City of Lone Tree Planning Commission Agenda Tuesday, February 23, 2016

TO: City of Lone Tree Planning Commission

Approval of a Site Improvement Plan (SIP) amendment for a two-story, 20,000-square-foot, mixed-use building designed for space above flexible retail and restaurant tenant space, on a 1.01 acre extent-of-work area in the master-planned, Lincoln District East portion of the Lincoln Commons development.

Project Name and File Number:	RidgeGate Sec. 15, Fil 5 2 nd Amdt, Lot 1-F1
Project Type:	SIP Application for 20,000 square-foot, mixed-use, office building
Comments Due By:	February 15, 2016 SP15-99R
If you are unable to respond by the due date, please contact the project planner

Graphic + comments from Daryl Heskin

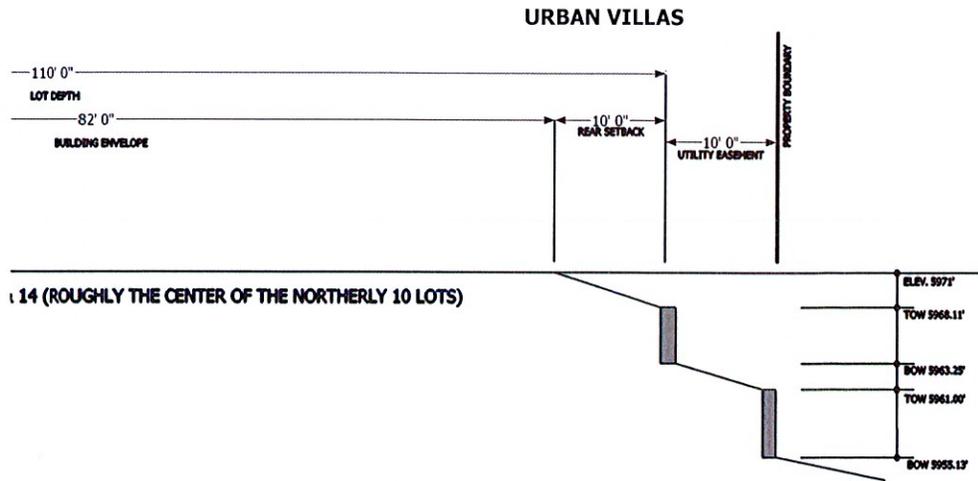
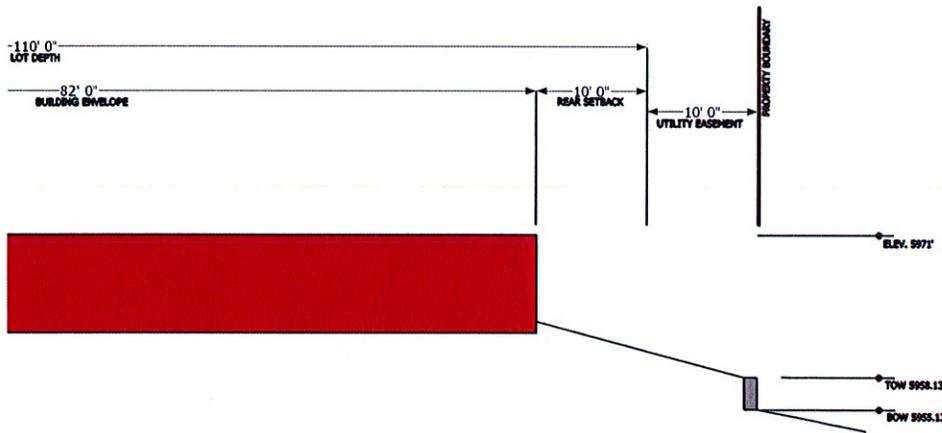
The above cross section of the site shows a section between lots 13 & 14 which are in the approximate center of the northerly building. The drawing is to scale and shows the steep grades in the "back yard" and in the utility easement.

The grade 5971' comes from the front of the unit at property line. I had to assume that it is somewhere near the garage/first floor level.

The lower drawing shows same cross section except the lower drawing shows a unit with a lower level reducing the height of the retaining walls.

PRELIMINARY PLAN

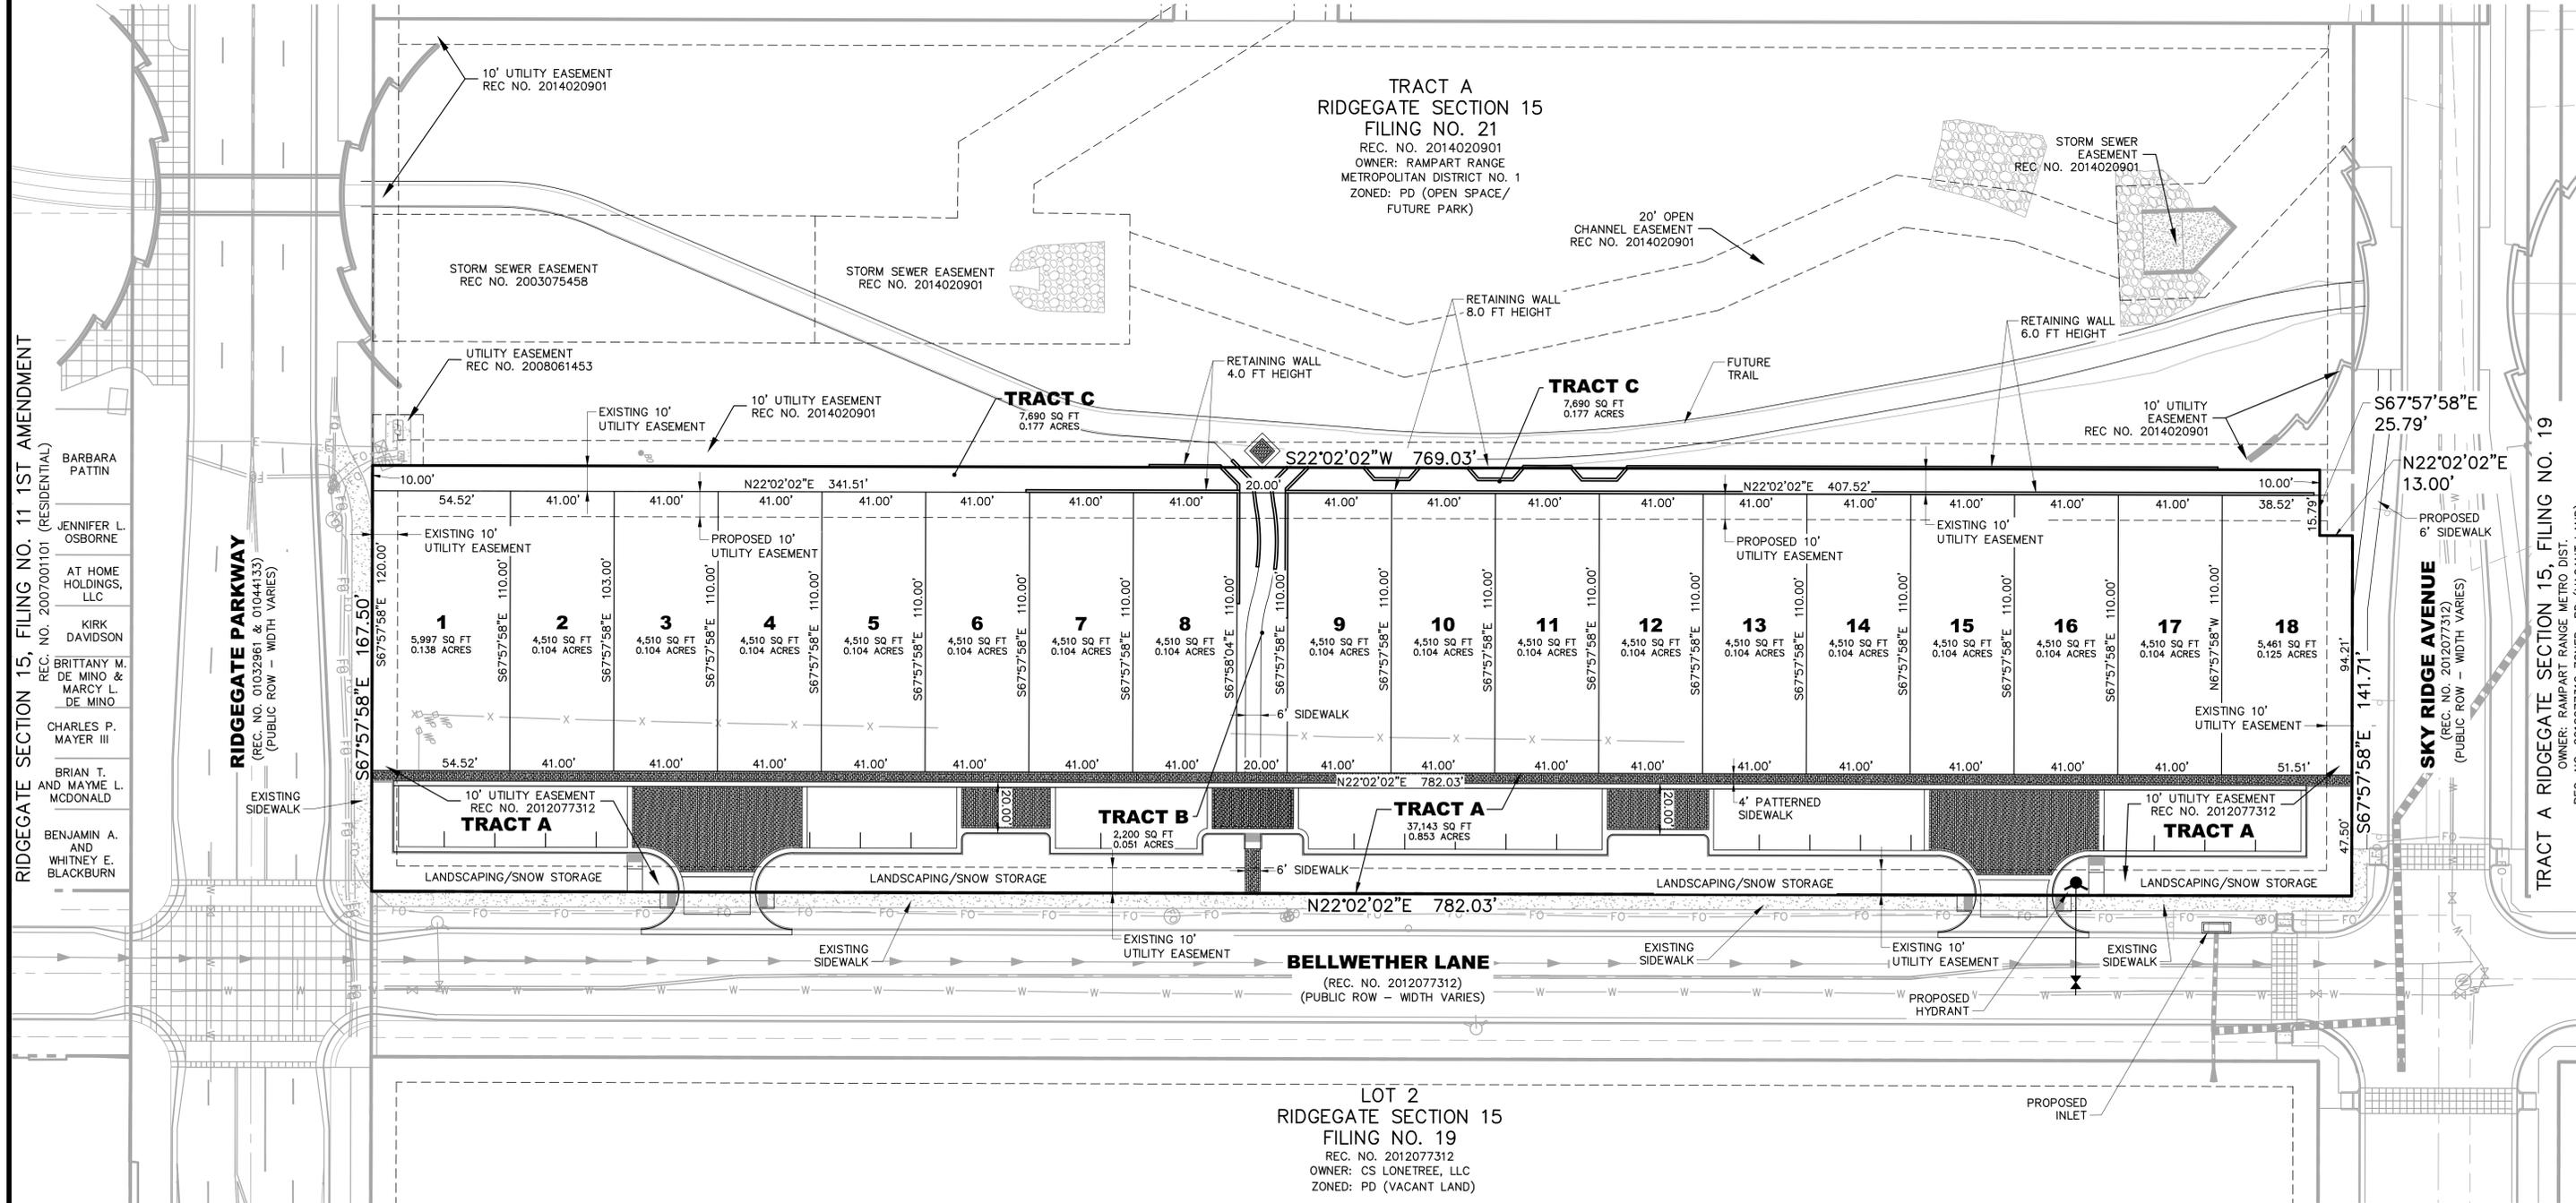
- 2) Please correct the Lot number in the title, in the title block at the bottom of each sheet and in any other reference to the original Lot number to: 3-A. (per the recorded Plat Correction Certificate)
- 3) Please correct the acreage of the site in the title to: 3.01. (per the recorded Plat Correction Certificate)
- 4) Please revise the Planning Project Number to: SB15-98R.
- 5) The areas and percentages in the Tract Summary and Development Statistics tables will have to be revised, or confirmed, due to the change in the boundary on Sheets 2, 3 and 4, per the boundary of the Lot, shown in the recorded Plat Correction Certificate.
- 6) Please confirm the information in the Development Standards table as it currently doesn't match the lot information shown on Sheet 2.

5. The areas and percentages in the Tract Summary and Development Statistics tables will have to be revised, or confirmed, due to the change in the boundary on Sheets 2, 3 and 4, per the boundary of the Lot, shown in the recorded Plat Correction Certificate.
Response: Understood, we are reviewing these issues.

6. Please confirm the information in the Development Standards table as it currently doesn't match the lot information shown on Sheet 2.
Response: Understood, we are reviewing these issues.
